## PLANNING AND ZONING COMMISSION AGENDA – Regular Meeting

Monday, December 10, 2018  
Ketchum City Hall  
480 East Avenue North, Ketchum, ID 83340

- b. **ACTION – Two Six Zero Mixed-Use Building**: 260 N. First Ave. (AM Lot 5A, Block 38) The Commission will consider and take action on a Pre-Design Review Application for a three-story commercial/multi-residential structure.

### STAFF REPORT KETCHUM PLANNING AND ZONING COMMISSION REGULAR MEETING OF DECEMBER 10, 2018

1 ROOF PLAN  
 A2.5 SCALE: 3/16" = 1'-0"

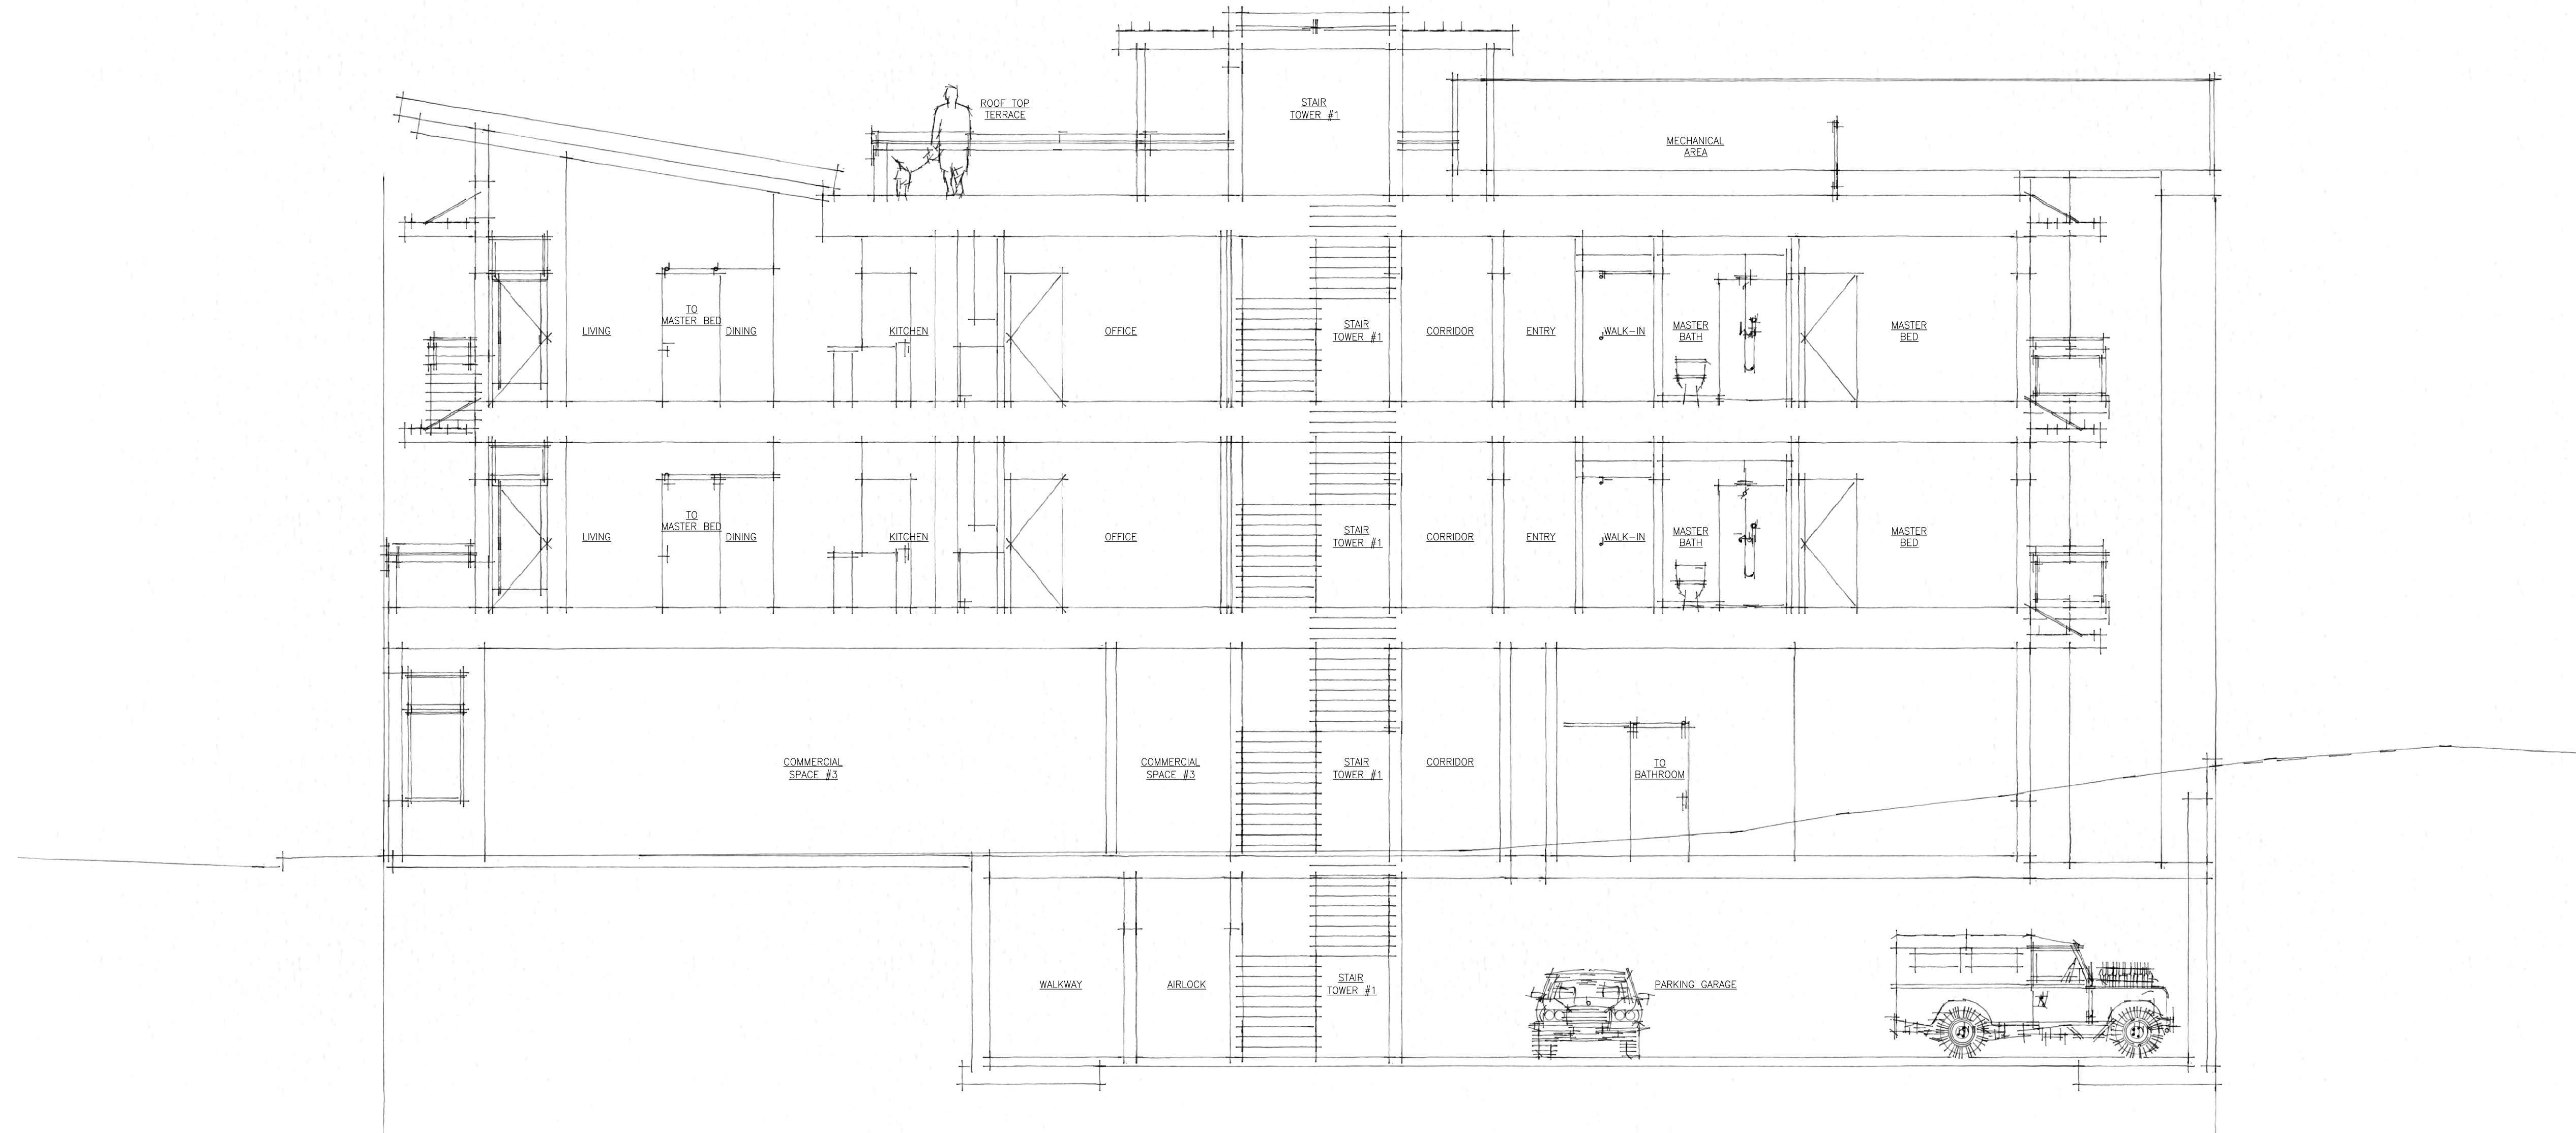
- The Roof Plan (Sheet A2.5) of the Pre-Application submittal indicates the siting of a stair tower, trellis courtyard, and mechanical equipment affixed to the roof. The applicant must indicate the setback of
